Hornsea Project Four

Signposting document of responses to Mr and Mrs Taylor Deadline 3 Submission

Document Reference: G4.8

Onshore Substation Flood Zones

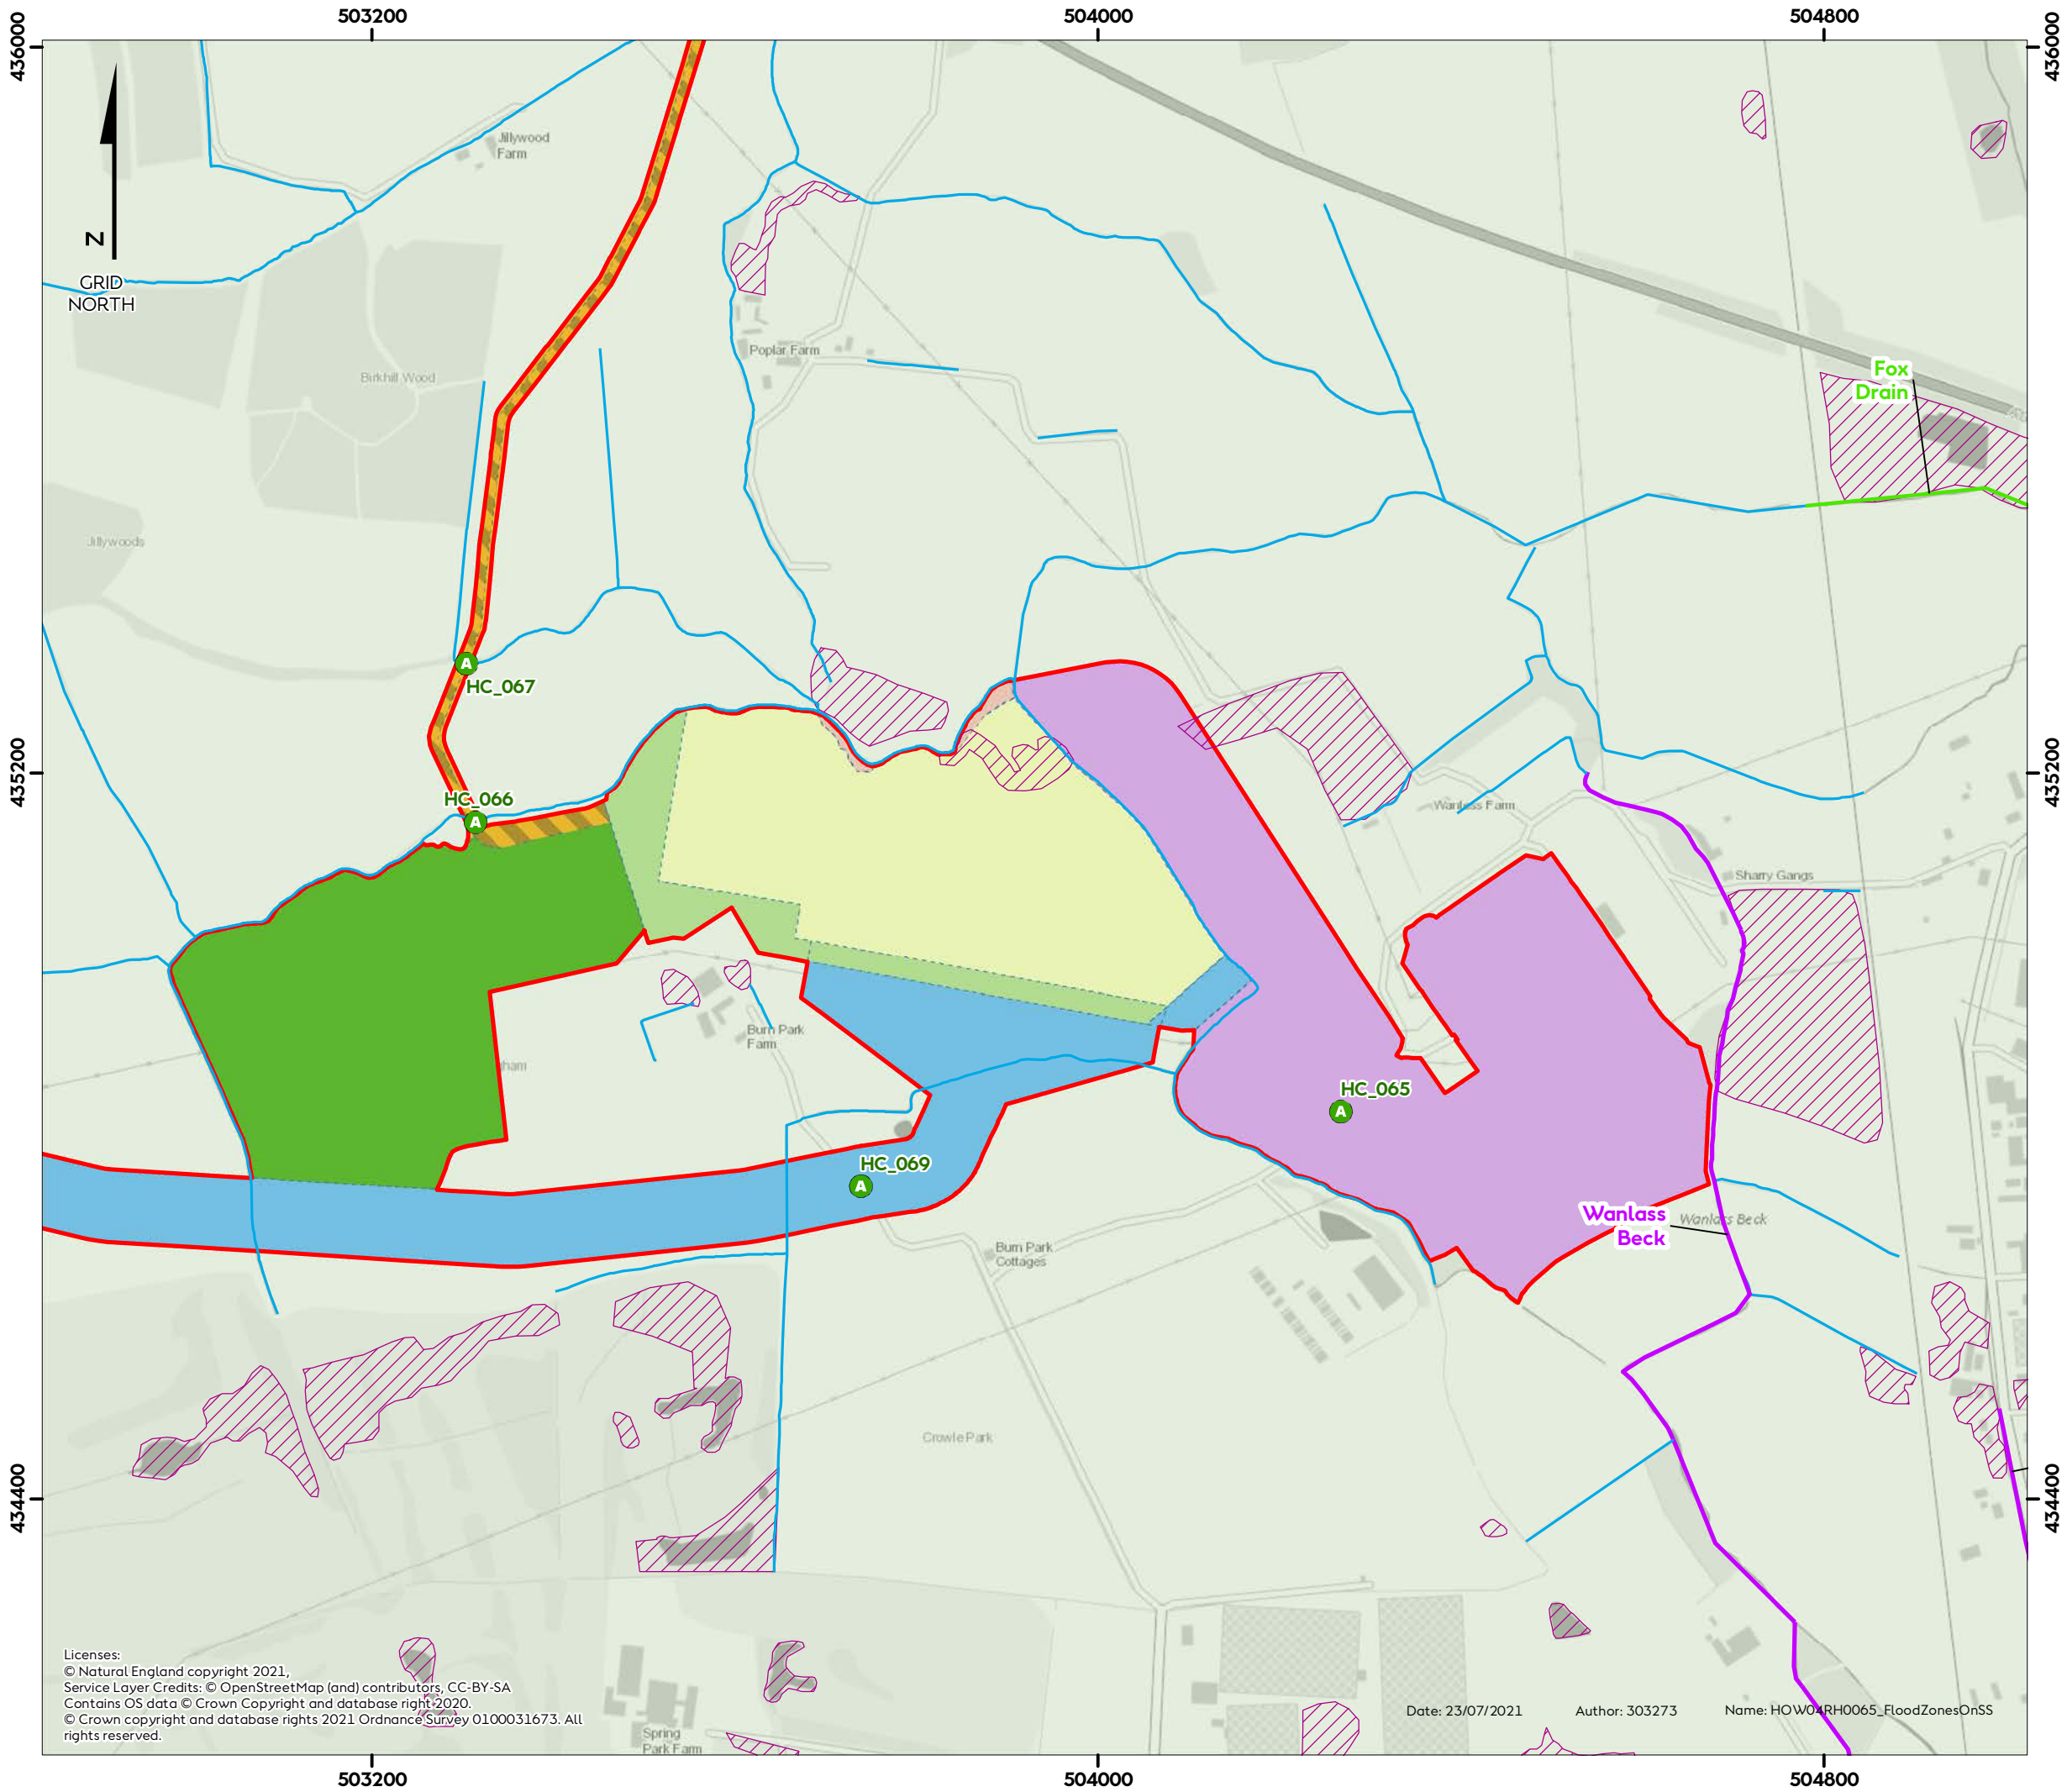
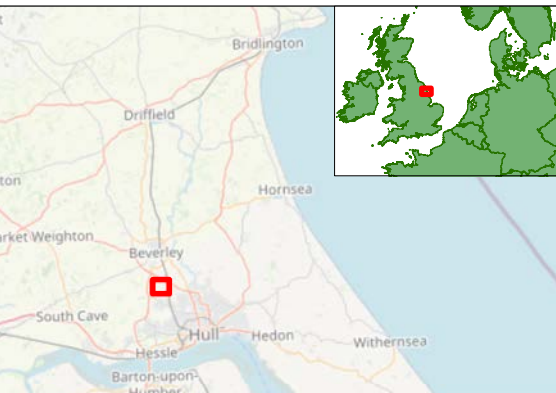
Comment Raised at Deadline 3	Summary of Applicant's Response	Signposting to Relevant Submission Documents
<p>Flooding in Field No TAO 335 8605. Site of the converter stations.</p> <p>Situated on the East and North East boundaries is an area of low lying land of approximately 3 acres. With increasing Climate Change, now in Summer and Winter, after a period of heavy rain of one inch or less, it holds the water from the surrounding fields. It acts as an Attenuation Pond, this helps to prevent flooding towards Cottingham which was badly flooded in July of 2007. It works in a similar way to the several Attenuation Chambers constructed around the local area. My husband, who has farmed here all his working life knows this area has tended to flood each year. Several attempts to drain it were unsuccessful, so it was</p>	<p>An Onshore Infrastructure Flood Risk Assessment (FRA) was developed in consultation with the Environment Agency and Lead Local Flood Authority. All sources of flooding have been taken into consideration throughout the FRA when considering the siting and design requirements for the Hornsea Four Onshore Substation (OnSS).</p> <p>The Applicant has engaged with both the Environment Agency and Lead Local Flood Authority throughout the process, specifically with regard to flood risk issues at the OnSS, and they have confirmed there are no concerns related to the assessment of flood risk at the OnSS.</p> <p>The design would ensure that the OnSS would be elevated such that it would not be at risk from any source of flood risk, particularly fluvial or surface water flooding.</p> <p>The Onshore Infrastructure Drainage Strategy (Co19 of the Commitment Register) includes measures to limit discharge rates and attenuate flows to maintain greenfield runoff rates from the OnSS and therefore would not increase flood risk to neighbouring land.</p> <p>Appropriate flood risk mitigation measures at the OnSS are committed to, which is reflected in the following commitments (A4.5.2: Commitment Register (APP-050)):</p> <ul style="list-style-type: none"> • Co19: An Onshore Infrastructure Drainage Strategy will be developed for the permanent onshore operational development in accordance with the Outline Onshore Infrastructure Drainage Strategy. The Onshore Infrastructure Drainage Strategy will include measures to ensure that existing land drainage is reinstated and/or maintained. This will include measures to limit discharge rates and attenuate flows to maintain greenfield run-off rates at the Onshore Substation. The Onshore Infrastructure Drainage Strategy will be developed in line with the latest relevant drainage guidance notes in consultation with the Environment Agency, Lead Local Flood Authority, and relevant Internal Drainage Board as appropriate. • Co184: Where the permanent access track to the OnSS may be required to pass over an existing watercourse, the crossing will be appropriately designed to maintain floodplain capacity and/or flow conveyance, where reasonably practicable. This shall include an allowance for the predicted effects of climate change. 	<p>A6.2.2: Onshore Infrastructure Flood Risk Assessment (APP-098)</p> <p>A4.5.2: Commitment Register (APP-050)</p> <p>A6.2.2: Onshore Infrastructure Flood Risk Assessment (APP-098) B1.1.1 Consultation Report - Volume B1 - Annex 1.1: Evidence Plan (APP-130)</p> <p>F2.6 Volume F2.6: Outline Onshore Infrastructure Drainage Strategy (APP-241)</p> <p>A4.5.2: Commitment Register (APP-050)</p>

Comment Raised at Deadline 3	Summary of Applicant's Response	Signposting to Relevant Submission Documents
<p>sown with grass. A plan and photos taken in Nov 2019 will be forwarded.</p>	<ul style="list-style-type: none"> Co185: Where the permanent access track to the OnSS is within areas of flood risk (as shown on the Environment Agency Flood Map for Planning) it will be appropriately designed to maintain existing ground elevations to ensure continued floodplain capacity and/or flow conveyance, where reasonably practicable. Co191: The drainage design at the onshore substation will include Sustainable Drainage System (SuDS) measures including filter drains, swales, attenuation and flow control structures for the operational drainage of the Onshore Substation. Surface water will be discharged from the site at a controlled rate which will be determined during the detailed design stage. Appropriate consideration will be given to maintaining the existing floodplain capacity and / or flow conveyance during extreme rainfall events. These principles are provided in the Outline Onshore Infrastructure Drainage Strategy with which the Onshore Infrastructure Drainage Strategy will be developed. <p>Furthermore, the Onshore Infrastructure Drainage Strategy will be developed in line with the latest relevant drainage guidance notes in consultation with the Environment Agency, the Lead Local Flood Authority, and relevant Internal Drainage Board, as appropriate. This is secured via Requirements 13 and 15 of the draft DCO which adequately secures the flood mitigation measures.</p> <p>The Applicant notes the reference to surface water flooding in the north-east corner of Field No TAO 335 8605. The Applicant confirms that surface water flooding at the OnSS, including in this location, has been considered within A6.2.2: Onshore Infrastructure FRA (APP-098). Figure 18 of the A6.2.2: Onshore Infrastructure FRA (APP-098) (also included as Figure 1 below) highlights this corner of the field as comprising a known historical flooding location. This is further confirmed by the surface water mapping reproduced on Figure 19 of the A6.2.2: Onshore Infrastructure FRA (APP-098) (also included as Figure 2 below), which shows this lower-lying area of the field as being at increased surface water flood risk.</p> <p>As part of the A6.2.2: Onshore Infrastructure FRA (APP-098), the assessment considered potential flood risk to Hornsea Four as well as the potential impact to off-site receptors. With regard to surface water flooding, Section 2.10 of the A6.2.2: Onshore Infrastructure FRA (APP-098) provides a summary of key actions undertaken by East Riding of Yorkshire Council (ERYC) following the flooding in July 2007,</p>

Onshore Substation Surface Water Flood Risk

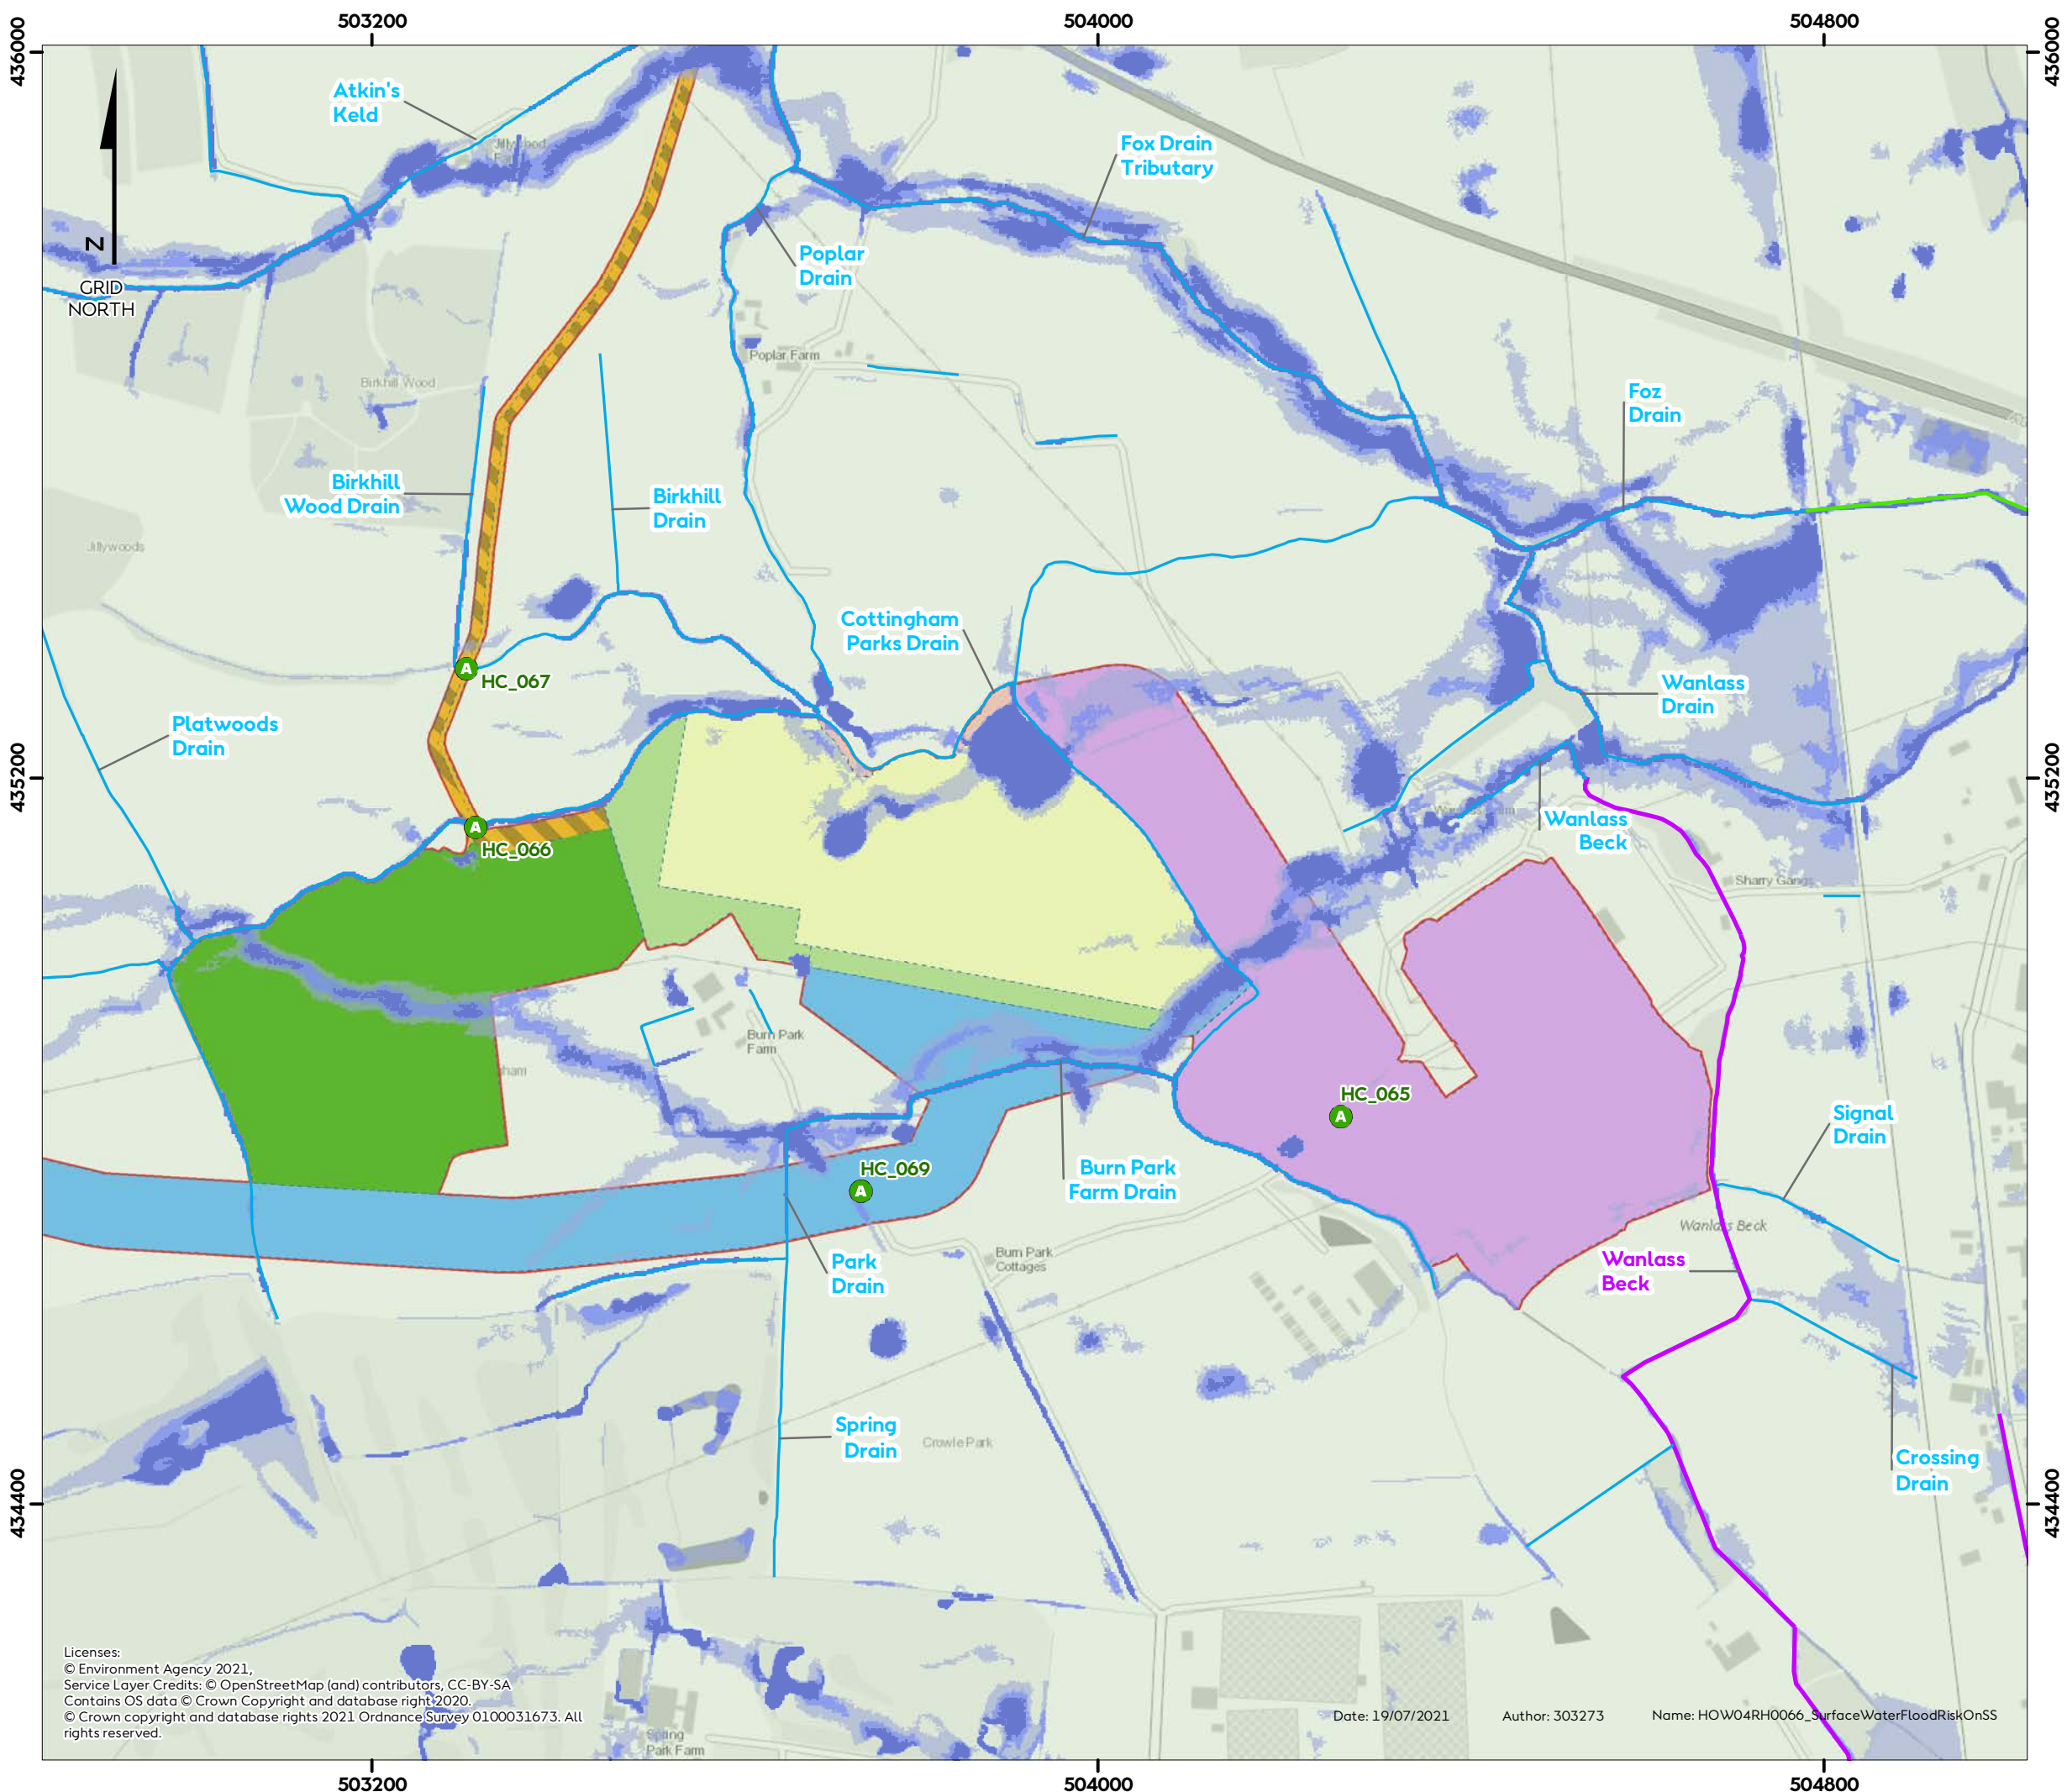
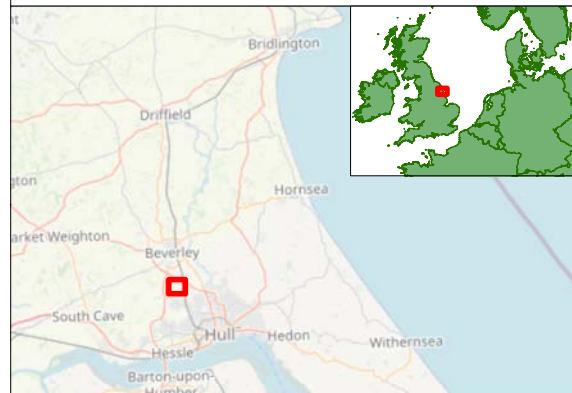
<p>Field No TAO 334 4672</p> <p>Situated to the South, which is on the Cable Route, has Springs here which rise and flow following similar weather.</p>	<p>The Applicant notes the reference to the presence of springs in Field No TAO 334 4672. Both the potential for groundwater and surface water flooding at the OnSS and along the onshore ECC has been considered within A6.2.2: Onshore Infrastructure FRA (APP-098).</p> <p>Section 4.8.6 of A6.2.2: Onshore Infrastructure FRA (APP-098) noted the potential for groundwater emergence to occur around the OnSS. Further to this, Figure 19 of the A6.2.2: Onshore Infrastructure</p>	<p>A6.2.2: Onshore Infrastructure Flood Risk Assessment (APP-098)</p> <p>A4.5.2: Commitment Register (APP-050)</p>

Comment Raised at Deadline 3	Summary of Applicant's Response	Signposting to Relevant Submission Documents
	<p>FRA (APP-098) (also included as Figure 2 below) shows the potential for surface water flooding and / or flow paths within Field No TAO 334 4672.</p> <p>The potential surface water flooding or flow path in this location would only interact with the onshore ECC and, as such, once constructed all works would be located below ground. During construction, the Applicant has confirmed that drainage channels will be installed on either one or both sides of the onshore ECC to ensure that direct impacts to the hydraulic regime are not altered, to be developed in consultation with the Environment Agency and LLFA / IDB, as appropriate (Co19 of A4.5.2: Commitment Register (APP-050)).</p> <p>Therefore, it is concluded that there would be no impact on the above ground surface water flow path as a result of Hornsea Four.</p> <p>Furthermore, to ensure there is no impact on groundwater flow, Co13 of A4.5.2: Commitment Register (APP-050) provides a commitment that measures will be implemented to ensure that the cable trench does not become a conduit for groundwater flow. All such measures will be identified following consultation with the Environment Agency and will be reported within the CoCP (Co124).</p> <p>On this basis, the Applicant considers the above mitigation is sufficient to avoid significant impacts related to flood risk arising from Hornsea Four.</p>
